Project	<b>IEEE 802.16 Broadband Wireless Access Working Group</b> < <a href="http://ieee802.org/16">http://ieee802.org/16</a> >	
Title	<b>Fixes for Lost of MOB_HO-IND (reject) Messages</b>	
Date Submitted	<b>2008-03-10</b>	
Source(s)	Chi-Chen Lee, I-Kang Fu MediaTek Inc. No. 1, Dusing Rd. 1 Science-Based Industrial Park, Hsinchu, Taiwan 300	<a href="mailto:chichen.lee@mediatek.com">chichen.lee@mediatek.com</a> <a href="mailto:IK.Fu@mediatek.com">IK.Fu@mediatek.com</a>
Re:	IEEE 802.16 Letter Ballot Recirculation #26b, on P802.16Rev2/D3, as announced in IEEE 802.16-08/006.	
Abstract	In IEEE 802.16 Rev2/D3, there is no definition on MS's/BS's behavior when the message MOB_HO-IND message with the HO Reject commend is lost. This contribution explains the potential problems and proposes a resolution to resolve this confusion.	
Purpose	Accept the proposed text modification to IEEE 802.16 Rev2	
Notice	<i>This document does not represent the agreed views of the IEEE 802.16 Working Group or any of its subgroups. It represents only the views of the participants listed in the "Source(s)" field above. It is offered as a basis for discussion. It is not binding on the contributor(s), who reserve

Figure 1 – Lost of MOB\_HO-IND (reject) message

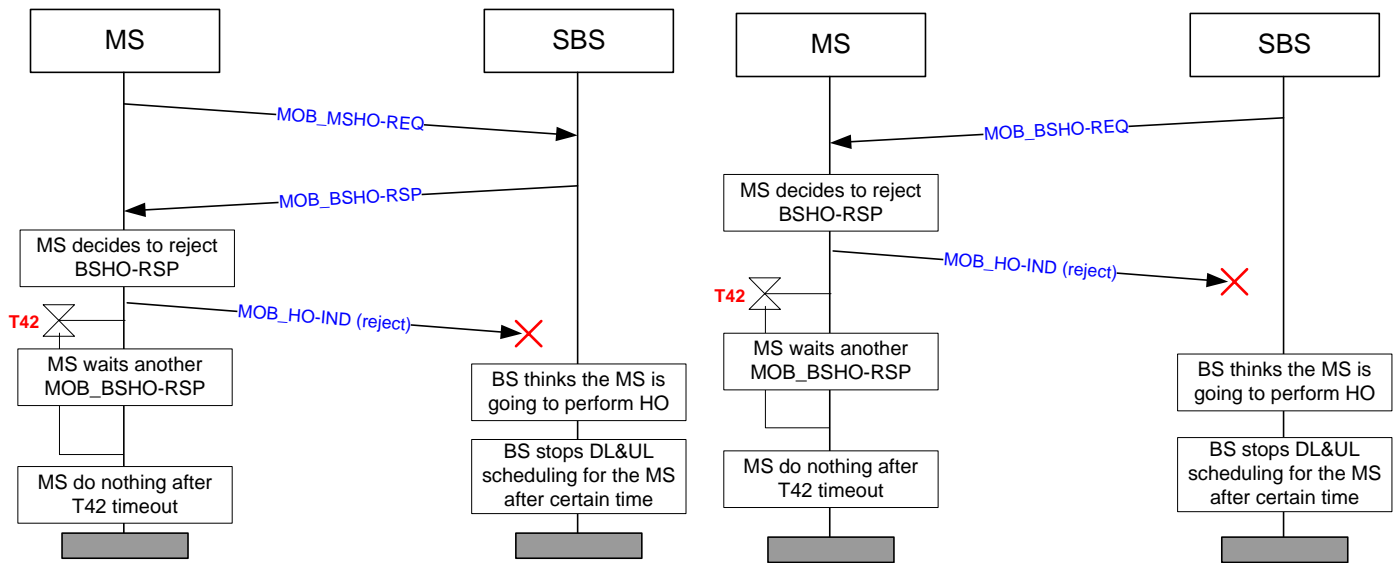
Current standard is not clear about what should MS behave after expiration of T42 when rejecting HO. For example, Figure 149 indicates that the HO exchange ends without any further action at MS after expiration of T42. However, the MS should decide to send the MOB\_MSHO-REQ message to start another HO negotiation or send MOB\_HO-IND (release) message to perform HO in case of the harsh link quality. The problematic scenarios are described in Figure 1.

If the MS signals rejection of serving BS instruction to HO through HO\_IND\_type field in the MOB\_HO-IND set value of 0b10 (HO reject option), the BS may reconfigure the neighbor BS list and retransmit MOB\_BSHO-RSP message including a new neighbor BS list. MS shall start T42 after sending MOB\_HO-IND message with HO\_IND type = 0b10. When T42 is expired and MS does not receive another MOB\_BSHO-REQ or

MOB\_BSHO-RSP message from BS, MS may either transmit MOB\_MSHO-REQ message to renegotiate target BS or transmit MOB\_HO-IND message to perform HO.
